Annat

23

- 65 - Scottish Natural Heritage [Written Submissions]
Modification Objector # 1 - Mr D J MacLean [Written Submissions]
Modification Objector # 2 - Mr A M Macdonald [Written Submissions]
Modification Objector # 3 - Mr T D Gray [Written Submissions]

← Extract from Proposals Map Annat Inset, as shown in the deposit draft Wester Ross Local Plan.

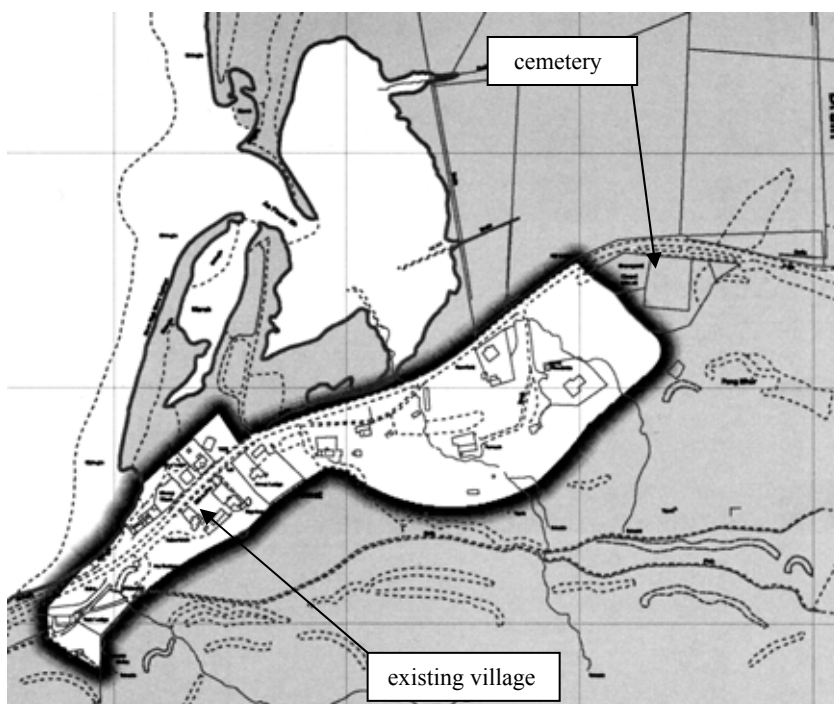
3. The objector pointed out that the Settlement Development Area had been drawn to include an area to the north-east of the original settlement, while part of the original settlement boundary to the south had been excluded.

The additional area took the settlement boundary beyond the point identified in the Landscape Character Study as being the eastern settlement limit (ie near the cemetery). Apart from the ground where two houses were being built, this area comprised steep slopes, which already defined the limits of the settlement to the west.

4. The objector accepted that the reasons for extending the settlement boundary to the north-east were to include the new house sites but considered that there was no scope in landscape terms for development on the higher ground to the south of the road and east of the cemetery. Nevertheless, there might be limited scope for further house sites in the low lying area of the two new houses. The Settlement Landscape Capacity Study included a broad area to the south of the village which was said to offer “limited opportunities for new, small scale housing between rocky outcrops and on flatter areas higher up hill slopes.”

Plan produced by the council to show modification to the settlement boundary. 6. There were three objections to such a modification.

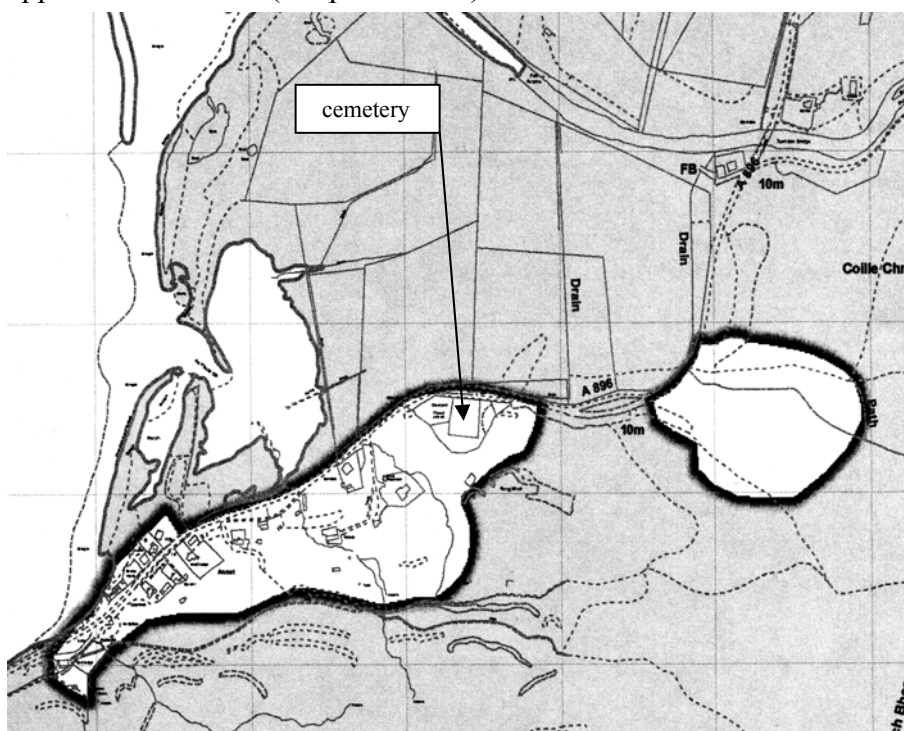
5. The council accepted the objector’s submission that the Settlement Development Area included an area of land to the east of the cemetery where the nature of the ground was unsuitable for development. It was therefore proposed to amend the boundary to exclude all land to the east of the cemetery (and this proposed modification was shown on an additional plan (see left).

These objections considered the objections to the deposit draft plan were misleading, as the areas to the east of the cemetery were low-lying, and not visible from the main road to the south, nor from the public footpath nor even from the other side of the loch, being screened by trees on the north side of the main road, and it was therefore suitable for development. Historically, croft houses started at Brownhill, just south of the Torridon River. By contrast, land to the west of the cemetery provided little scope for further housing, most of the available sites on it already having been used up. There was a shortage of accommodation in the area as “thousands of people wished to come to Torridon; accordingly a need existed to attract new crofters and permanent residents, although 50% of the usable houses had been converted to holiday homes.

- (i) the Proposals Map Inset for Annat be amended to that shown at paragraph 5;
- (ii) the Development Factor set out in paragraph 2 be restored to the plan; and
- (iii) in association with Scottish Natural Heritage, the extent of the area to the east of the rocky outcrop be identified and mapped as an Area of Avoidance.
